## Product / Process Change Notification (PCN)

**PCN #:** PCN\_FeTEMA\_20220603

**Affected Series:** 782115xxxx

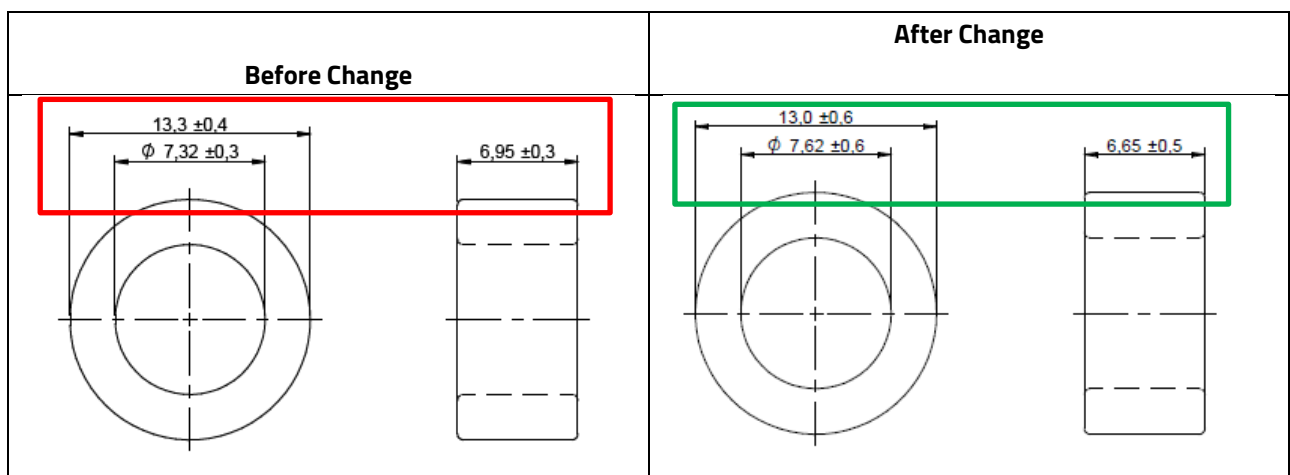
Because of a database mismatch, Würth Elektronik will correct some dimensions and tolerances in the drawing.

WE partnumber	OD	Tol	ID	Tol	H	Tol
	mm	mm	mm	mm	mm	mm
782115069064	13.3	±0.4	7.32	±0.3	6.95	±0.3
782115070080	14.6	±0.4	9.4	±0.3	8.6	±0.3
782115110070	16.6	±0.3	11.4	±0.3	7.6	±0.3
782115222150	38.6	±0.6	21.4	±0.6	14.6	±0.4

WE partnumber	OD	Tol	ID	Tol	H	Tol
	mm	mm	mm	mm	mm	mm
782115069064	13.0	±0.6	7.62	±0.6	6.65	±0.5
782115070080	14.3	±0.6	9.7	±0.6	8.3	±0.5
782115110070	16.3	±0.6	11.7	±0.6	7.3	±0.5
782115222150	38.4	±0.9	21.6	±0.9	14.4	±0.7
